Rezoning Transportation Analysis

Petition Number: 2022-147

Date	Description
1-25-23	First Review (IW)

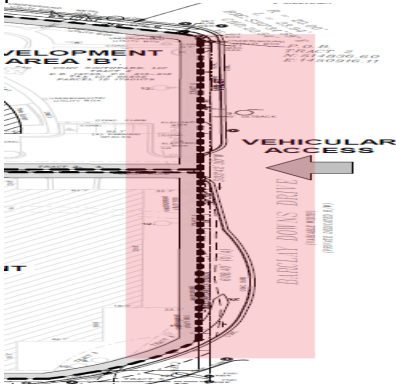
4. Revise site plan and conditional note(s) to commit to constructing The LOOP standard 12 foot sidewalk along the portion of the property frontage where The LOOP is designated to be constructed. As shown below, The LOOP path is along the southern portion of Barclay, goes North on Piedmont Row Drive, and crosses Fairview at the existing crosswalk.
